**PLANNED UNIT DEVELOPMENT &  
SUBDIVISION STAFF REPORT****Date: August 21, 2003**

<b><u>DEVELOPMENT NAME</u></b>	Providence Park Subdivision, Unit Seven
<b><u>SUBDIVISION NAME</u></b>	Providence Park Subdivision, Unit Seven
<b><u>LOCATION</u></b>	South side of Airport Boulevard, 280'± West of Providence Park Drive East
<b><u>PRESENT ZONING</u></b>	B-3, Community Business
<b><u>AREA OF PROPERTY</u></b>	3.7± Acres
<b><u>CONTEMPLATED USE</u></b>	Shared parking and access between multiple lots
<b><u>TIME SCHEDULE FOR DEVELOPMENT</u></b>	Immediate
<b><u>ENGINEERING COMMENTS</u></b>	Must comply with all stormwater and flood control ordinances. Any work performed in the right of way will require a right of way permit.
<b><u>TRAFFIC ENGINEERING COMMENTS</u></b>	Driveway number, sizes, location and design to be approved by Traffic Engineering and conform to AASHTO standards.
<b><u>URBAN FORESTRY COMMENTS</u></b>	All work under the 30" Live Oak Tree is to be coordinated with Urban Forestry. A permit from the Mobile Tree Commission is to be obtained before median cutting is approved due to the existing trees. Property to be developed in compliance with state and local laws that pertain to t

# SITE PLAN

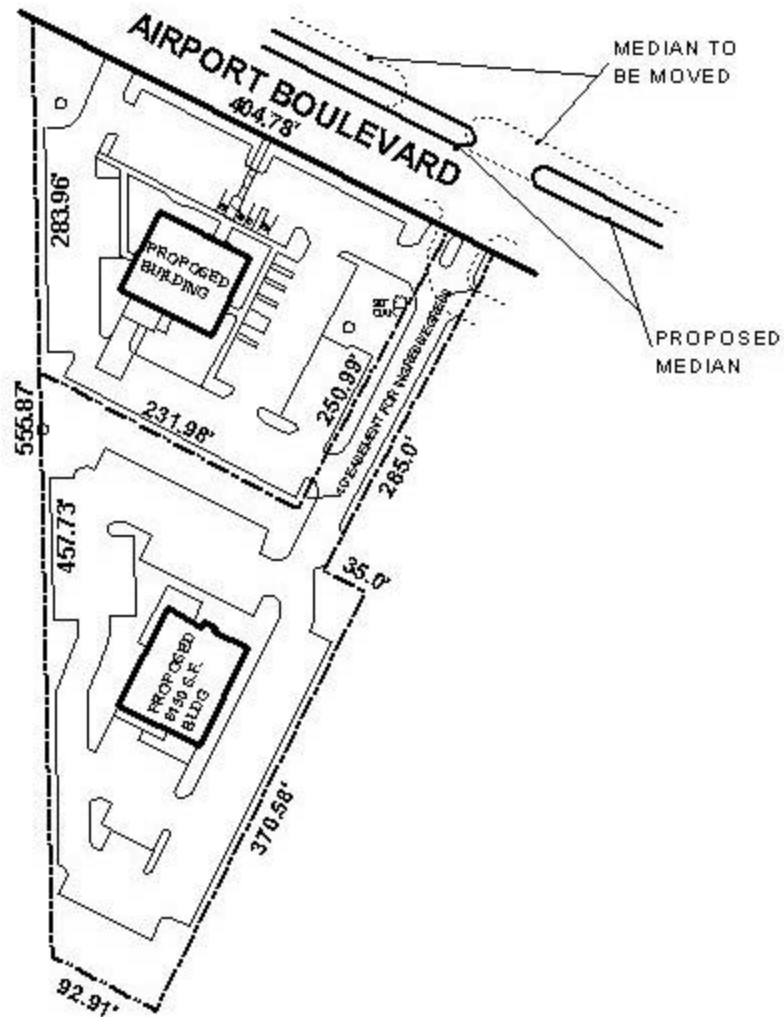
The development consists of two lots sharing parking and access to Airport Boulevard. Access to Providence Park Drive, a private street, is also provided through the adjacent lot at the Southeast corner of Airport Boulevard and Providence Park Drive. The site plan indicates that the two lots will be developed as restaurants and adequate parking and circulation is provided.

There is an existing 30-inch live oak on the site, and all work under this tree should be coordinated with Urban Forestry. As with any new development, the two lots must comply with the landscaping and tree planting requirements of the Ordinance; additionally, a sidewalk along Airport Boulevard is also required.

Also proposed is a modification to the existing median cut in Airport Boulevard. It should be noted that a permit from the Mobile Tree Commission is required before the median is altered due to the existing median trees.

The site fronts Airport Boulevard, a planned major street, which has an existing right-of-way in compliance with the Major Street Plan. As the site fronts a major street, access management is a concern; thus the site should be limited to two curb cuts, with the location and design to be approved by Urban Development and Traffic Engineering.

**Planned Unit Development:** Based upon the preceding this application is recommended for Tentative Approval subject to the following conditions: 1) that all work under the 30-inch live oak tree be coordinated with and approved by Urban Forestry; 2) full compliance with the landscaping and tree planting requirements of the Ordinance; 3) provision of a sidewalk along Airport Boulevard; 4) the approval of the Mobile Tree Commission for any work in the median that may impact existing median tree plantings; 5) that the site be limited to two curb cuts, with the exact location and design to be approved by Traffic Engineering and Urban Development staff; and 6) full compliance with all municipal codes and ordinances.

**Subdivision:** Based upon the preceding, this application is recommended for approval subject to the following condition: 1) placement of a note on the final plat stating that the site is limited to two curb cuts, with the location and design to be approved by Traffic Engineering and Urban Development staff.
